DESIGN RECOMMENDATION - PROJECT# 3022596

1638, 1640, & 1644 20TH AVE

MARCH 8TH, 2017 8:00PM

EDG RESPONSE

PARKING COURT

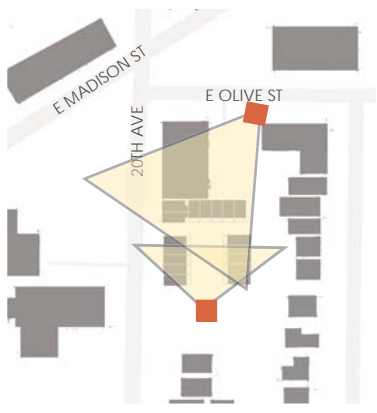
Define open space and vehicle access

2A

Connect southern amenity space to the central court

2B

Define pedestrian access

2C

COURTYARD CONCEPT

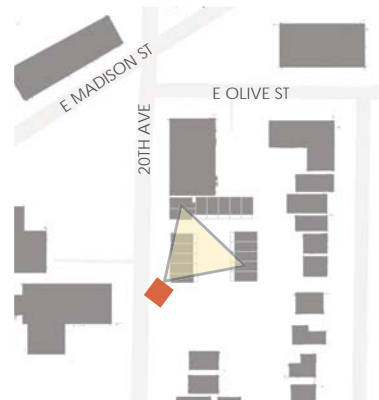
Define open space and vehicle access

2A

Connect southern amenity space to the central court

2B

Define pedestrian access

2C

Design common and private open spaces to encourage social interaction

4D

Develop outdoor space suited to the uses envisioned for the project

4D

DRIVEWAY WIDTH

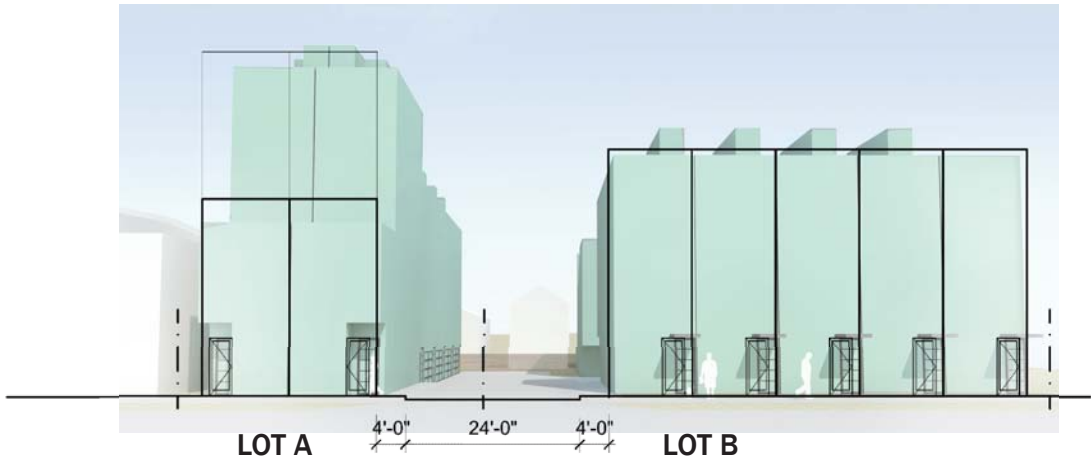
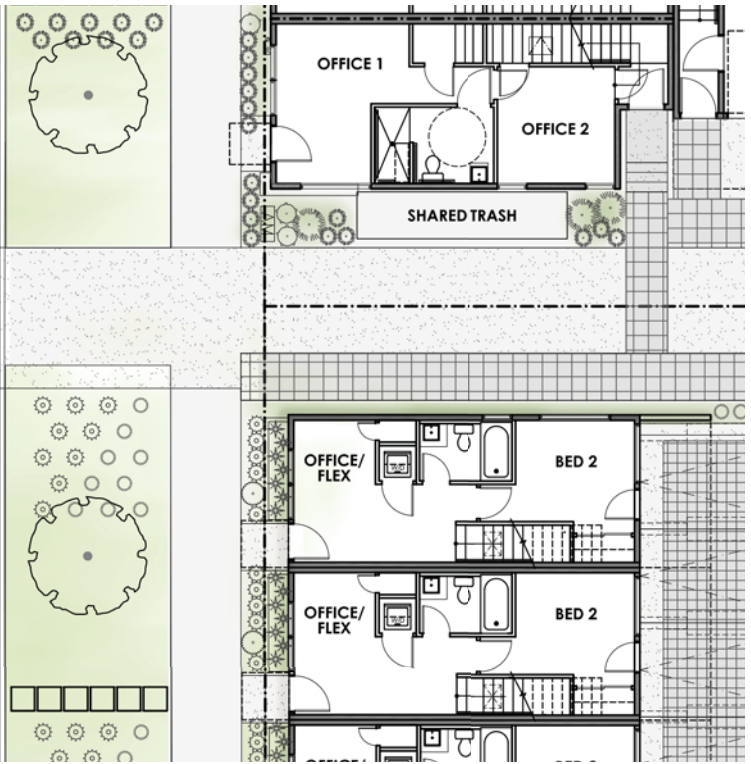
SMC 23.53.025.D. Vehicle Access easements serving ten or more residential units, easement width shall be a minimum of 32' and provide a surfaced roadway at least 24' wide.

Allow for a 10' curb cut and 14' drive. Hardscape of drive to consist of 9' of concrete and 4' of pedestrian walkway made of pavers.

Access and location designed to minimize the number and width of curb cuts and drive. Reduced width will reduce the visual impact of the vehicular access from the streetscape. (DC1-B1, DC1-C2, DC1-C3)

SIGHT TRIANGLE

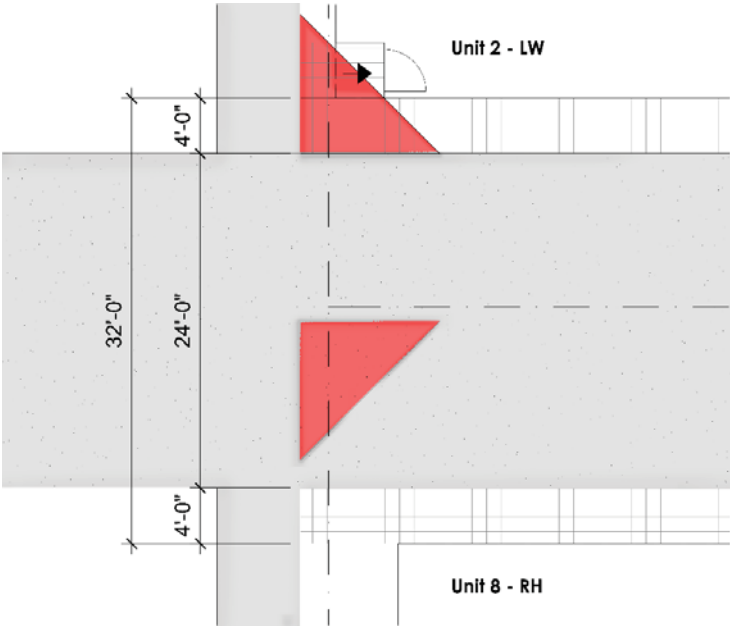
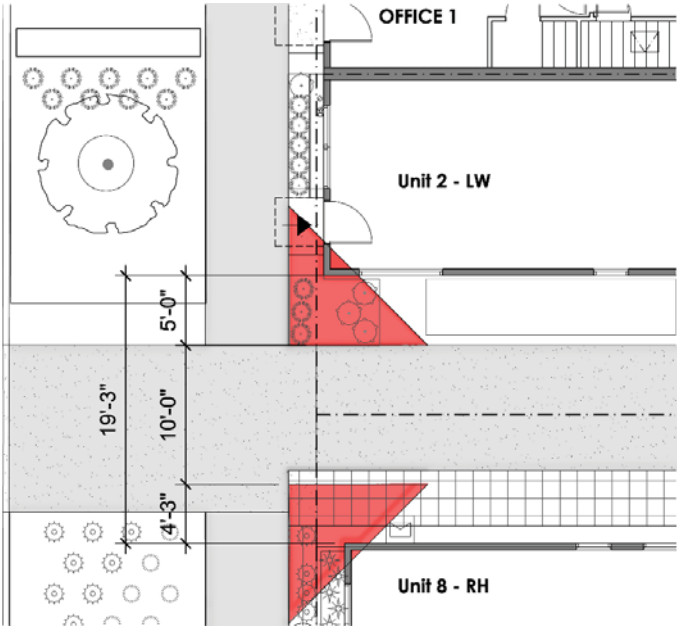
SMC 23.54.030.G.1. For exit-only driveways and easements, and two way driveways and easements less than 22 feet wide, a sight triangle on both sides of the driveway or easement shall be provided, and shall be kept clear of any obstruction for a distance of 10 feet from the intersection of the driveway or easement with a driveway, easement, sidewalk or curb intersection if there is no sidewalk.

Allow for a reduced sight triangle on either side of the driveway.

Reduce the setback of the live/work entries to provide a street-level experience and façade language more in keeping with the existing commercial adjacent to the north. (CS3-A1, PL3-B3)

SETBACKS FOR COMMERCIAL LOTS ABUTTING RESIDENTIAL ZONES

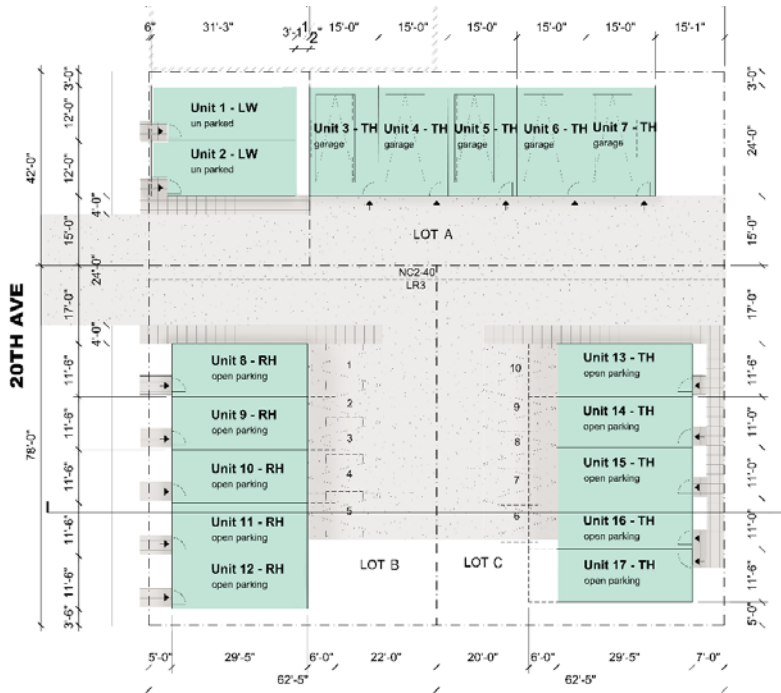
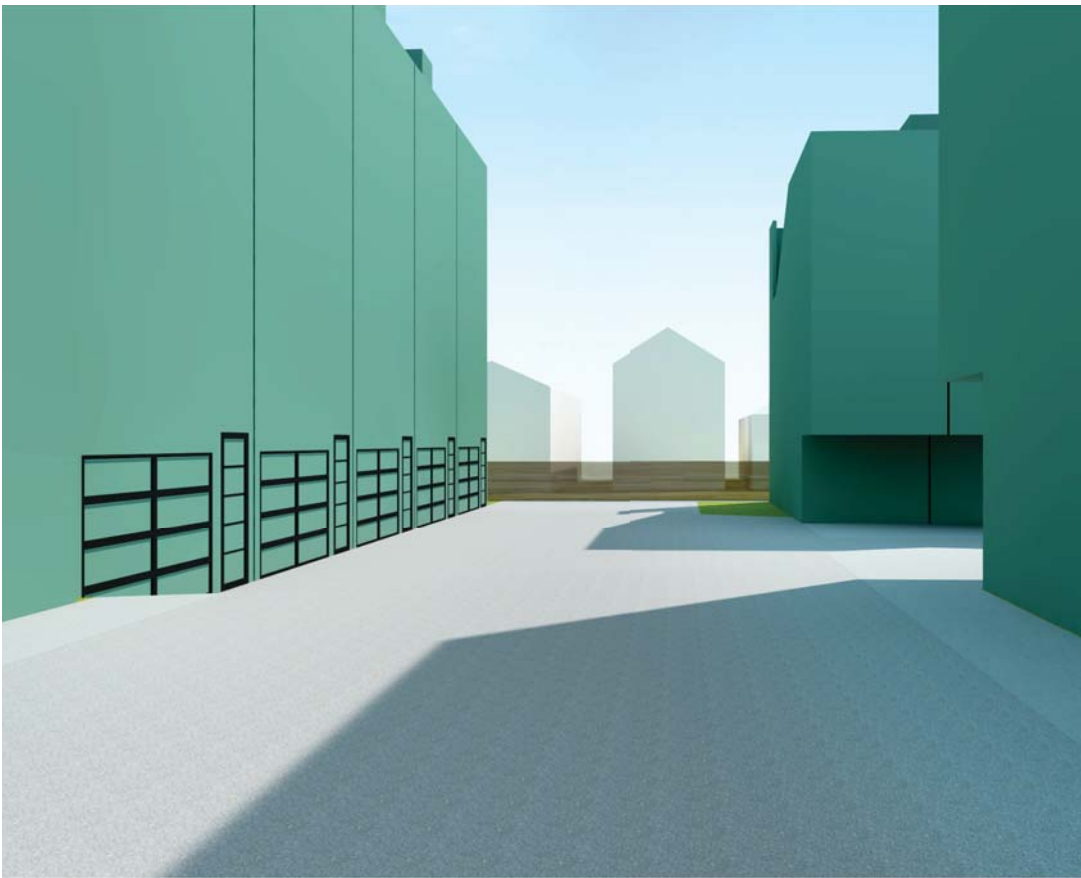
STANDARD
SMC 23.47A.014.B.1 A setback is required where a lot abuts the intersection of a side lot line and front lot line of a lot in a residential zone. The required setback forms a triangular area. Two sides of the triangle extend along the street lot line and side lot line 15 feet from the intersection of the residentially zoned lot's front lot line and the side lot line abutting the residentially zoned lot. The third side connects these two sides with a diagonal line across the commercially-zoned lot.

SMC 23.47A.014.B.2. A setback is required along any rear or side lot line that abuts a lot in a residential zone or that abuts a lot that is zoned both commercial and residential if the commercial zoned portion of the abutting lot is less than 50 percent of the width or depth of the lot, as follows:
a. Ten feet for portions of structures above 13 feet in height to a maximum of 65 feet;

SMC 23.47A.014.B.3. For a structure containing a residential use, a setback is required along any side or rear lot line that abuts a lot in a residential zone or that is across an alley from a lot in a residential zone, or that abuts a lot that is zoned both commercial and residential if the commercial zoned portion of the abutting lot is less than 50 percent of the width or depth of the lot, as follows:
a. Fifteen feet for portions of structures above 13 feet in height to a maximum of 40 feet; and
b. For each portion of a structure above 40 feet in height, additional setback at the rate of 2 feet of setback for every 10 feet by which the height of such portion exceeds 40 feet

DEPARTURE REQUESTED:
Reduce 15' setback for residential units to 10', reduce 10' setback for commercial units to 9'-8". Reduce street lot line side of setback triangle to 9'-8".

DEPARTURE RATIONALE:
Reduced residential setback allows façade modulation that provides interest and focus towards the residential portions of the unit and reduces the emphasis on the garage/vehicular access. Reduced commercial setback allows increased setback of live/works adjacent to north property line. Reduced setback triangle provides for a reduced separation between live/works and street-facing residential units providing less visual impact on parking and drive. (CS2-D1, DC1-C2)

FRONT SETBACK

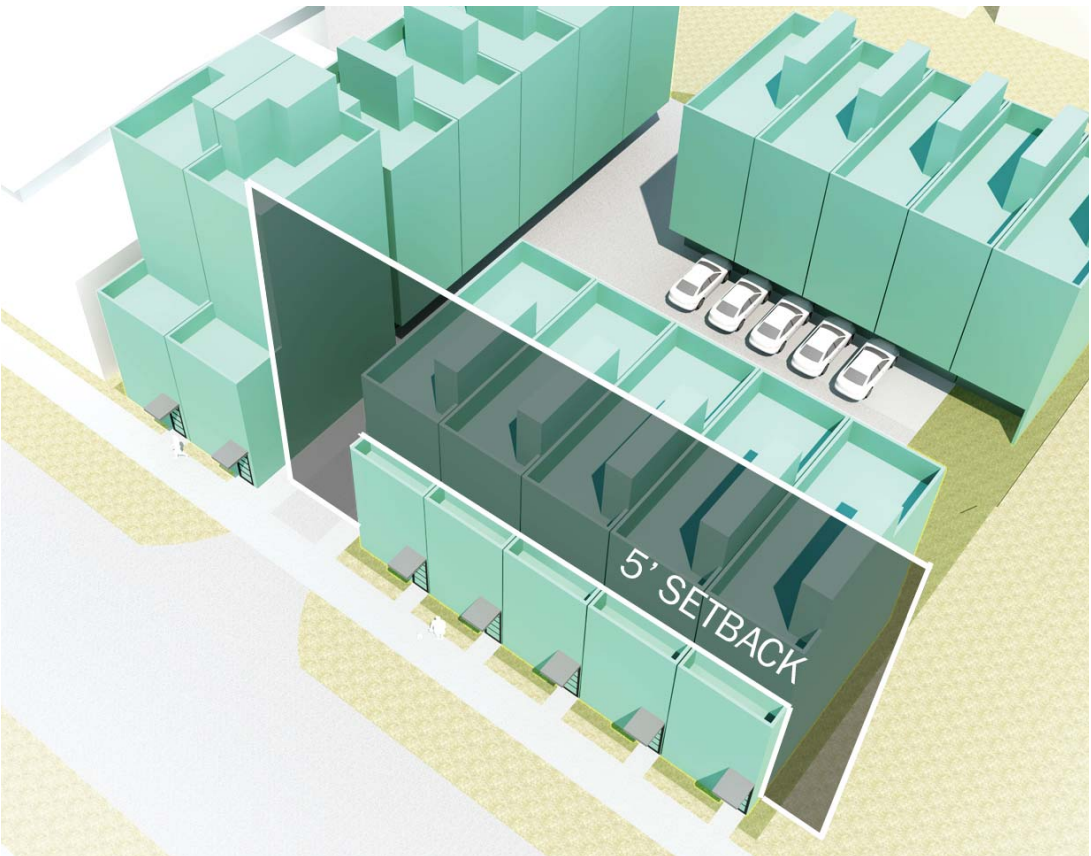
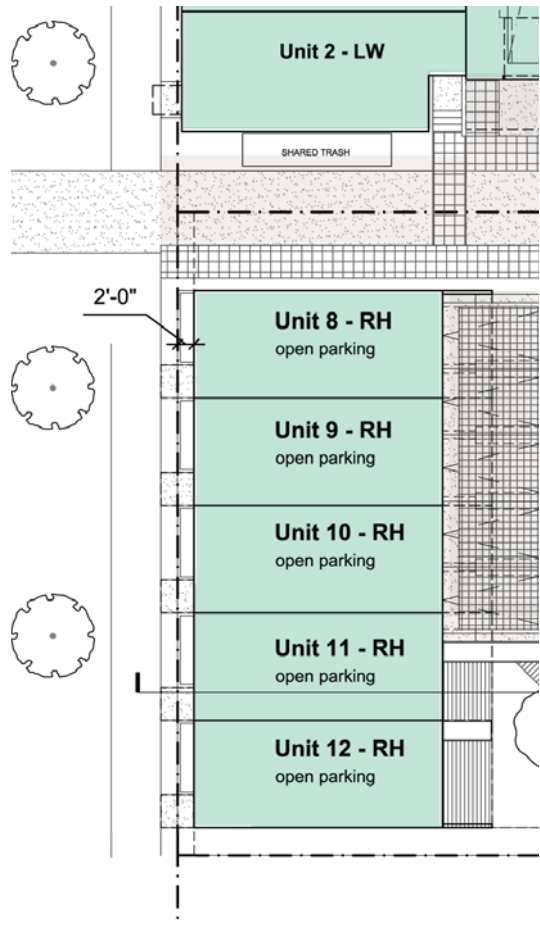
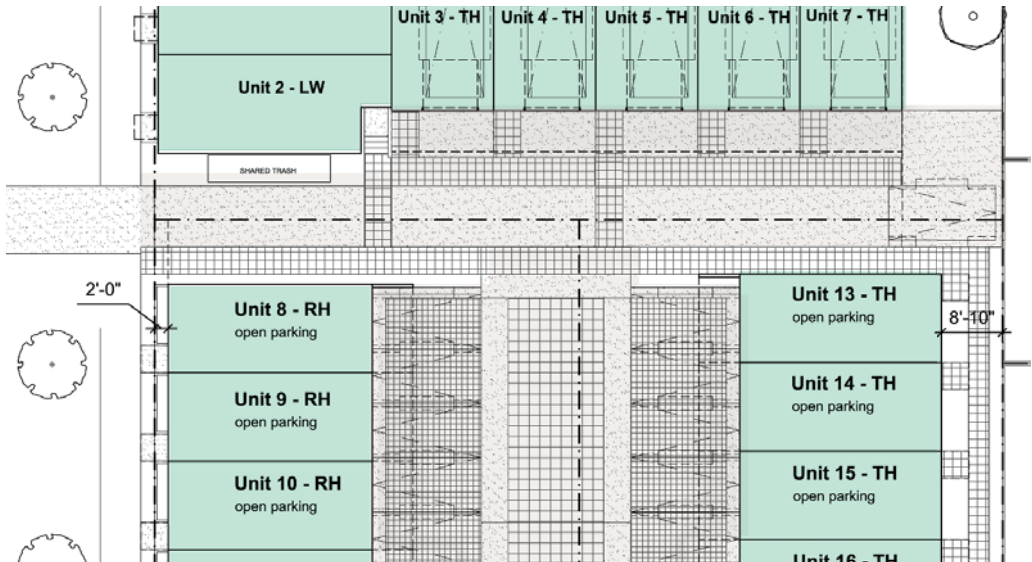
STANDARD
SMC 23.45.518.A. Front setback for rowhouse developments is a 5' minimum in an LR zone.

DEPARTURE REQUESTED:
Allow for a 2' front setback in LR zone for units 8-12

DEPARTURE RATIONALE:
This reduced front setback allows for a distinct transition along the street face between the zero setback at the commercial zone and the residential zone to the south. This shift west of rowhouse units 8-12 also allows townhouse units 13-17 to shift west and provide an increased setback of 8'-10" (5' min, 7' average required).
